**Subject:** Silver Valley Subdivision, Plan Review

**Subject:** Silver Valley Subdivision, Plan Review

We have reviewed the revised plans for the proposed Silver Valley Subdivision and have the following comments:

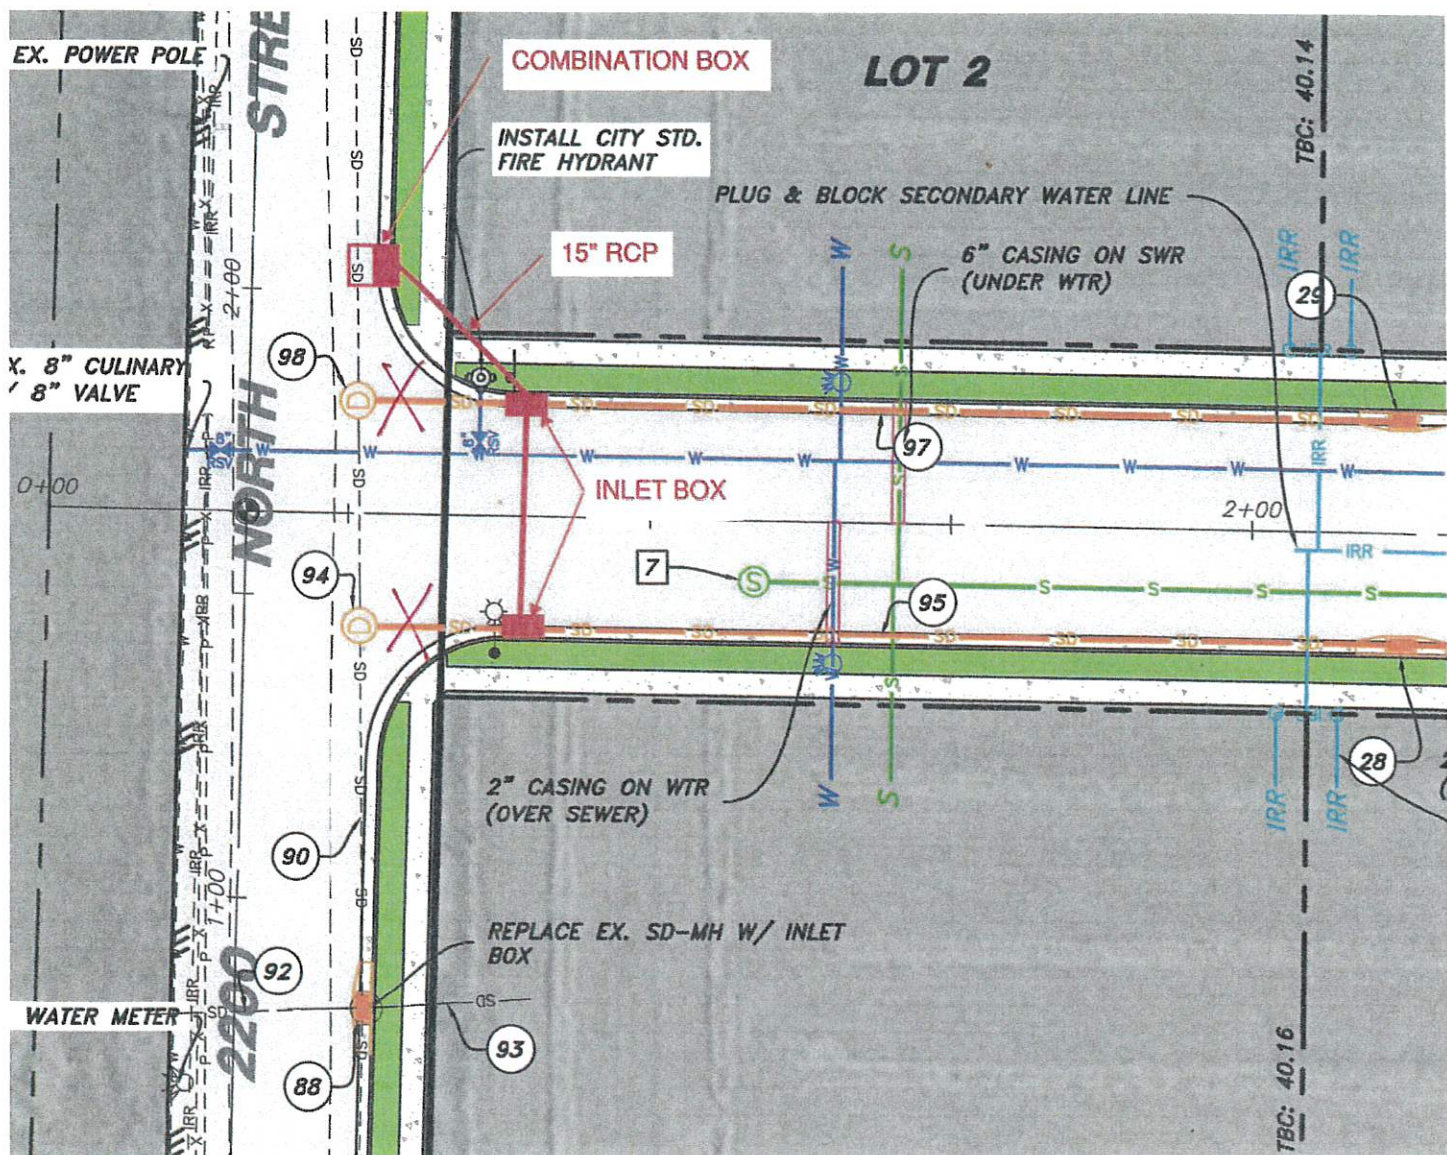
1. A geotechnical report should be provided for this development.
2. The plans show an irrigation ditch running east-west through the development between Lots 11 and 13 as well as Lots 12 and 14. Notes should indicate whether this ditch is to be abandoned or piped. If it is to be piped, the proposed improvements should be shown on the plans.

3. The plans note that fire hydrants are to be constructed in accordance with Plain City Standards. The note should be revised to state that the fire hydrants are to be installed in accordance with Bona Vista Water Improvement District Standards.

4. The street signs/stop signs shown on the plans should be noted.
5. A sanitary sewer line should be extended approximately 60-feet to the north from the proposed manhole at station 1+17.51. This sanitary sewer extension should terminate with a sewer cleanout.

7. The storm drain system at the intersection of 3050 West and 2200 North should be reconfigured as shown on the attached redlined drawing.
8. The 1975 North Typical Road Section on Sheet 1 indicates the asphalt widening will be approximately 17.5-feet while the plan on Sheet 6 shows the widening is just over 5-feet. Please note that the asphalt widening must be as wide as it needs to be to achieve an adequate cross slope.
9. Prior to construction beginning, an electronic drawing of the development layout should be submitted to our office. The drawing should be compatible with an AutoCAD format.
10. Final addresses and street numbers will be provided by our office.

1. A geotechnical report has been completed and is included with the most recent submittal set
2. The irrigation ditch has been marked as being abandoned
3. Fire hydrant notes have been updated
4. Street/stop signs have been noted (see sheet 2 & 3)
5. The sewer line cannot pass the storm drain lines as it conflicts directly with the SD. The sewer has been extended as far north as possible
6. Plans have been sent to Bona Vista & Pineview for review & approval
7. Storm drain has been reconfigured
8. Sheet 1 road section shows 17 feet of existing asphalt and only 4 feet of new asphalt which matches sheet 6
9. Electronic DWG will be provided upon final approval and prior to precon meeting
10. Addresses have been received and added to the plat map. Street numbers have been updated on all drawings
